City of Portland, Maine - Building or Use Permit Application

Permit No: 05-0140	Issue Date:	CBL: 347 B028001
-----------------------	-------------	---------------------

RE: 142 Hennessy Dr – 347-B-028 – R3 Zone – application #05-0140

RED - EXISTING PORCH

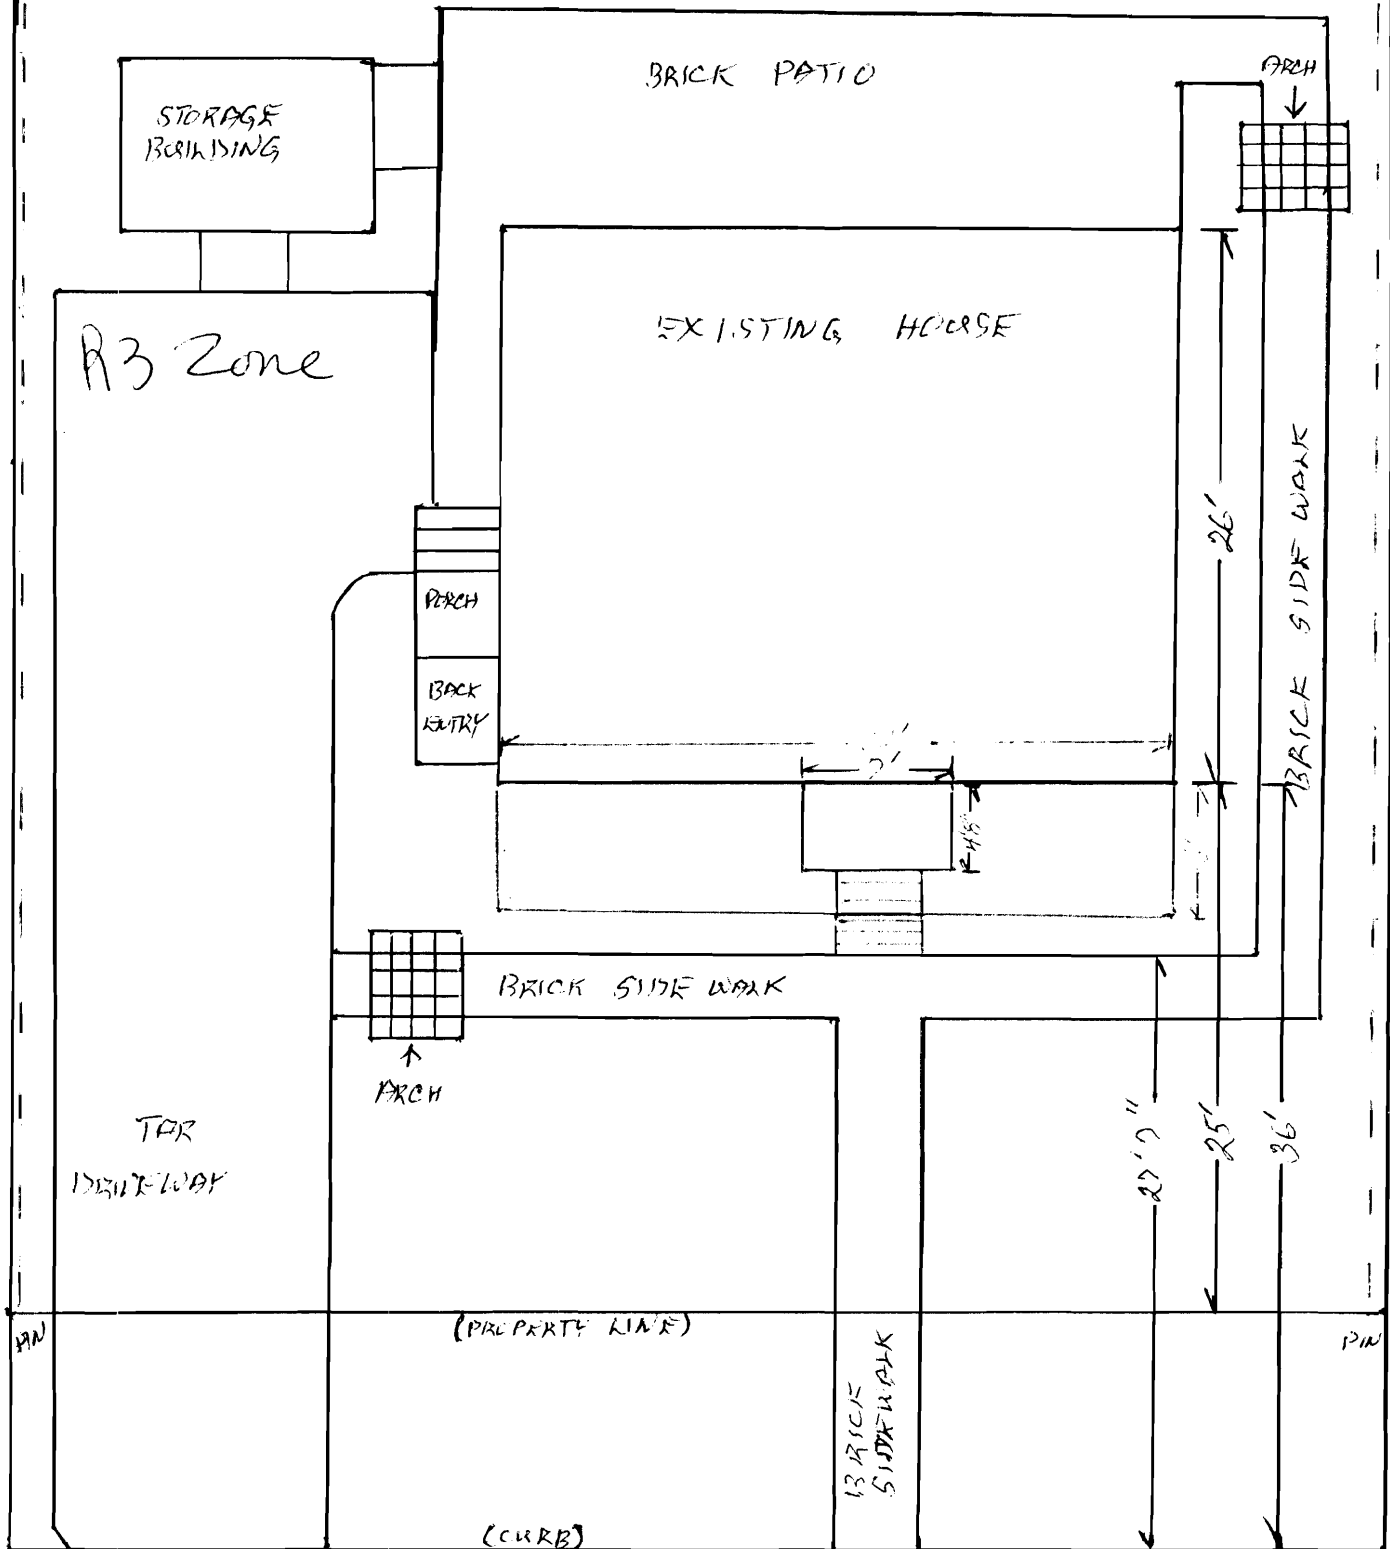
Note: 2/14/05 Spoke w/Susan St. P. To verify the property pins in front and the distance. The house is currently 25' from the front line. Only 50 sf is allowed into the setback. This permit is denied as submitted, if they want to re-build the existing porch new submissions will be needed. I gave my # to call with further questions before I formally deny it. **Ok to Issue:**

Section 14-90(d) 1 of the R3 Residential Zone requires a front setback to be a minimum of 25'. The submitted plot plan shows 18'. There are no exceptions to this zoning requirement; therefore, I cannot allow the construction of these decks.
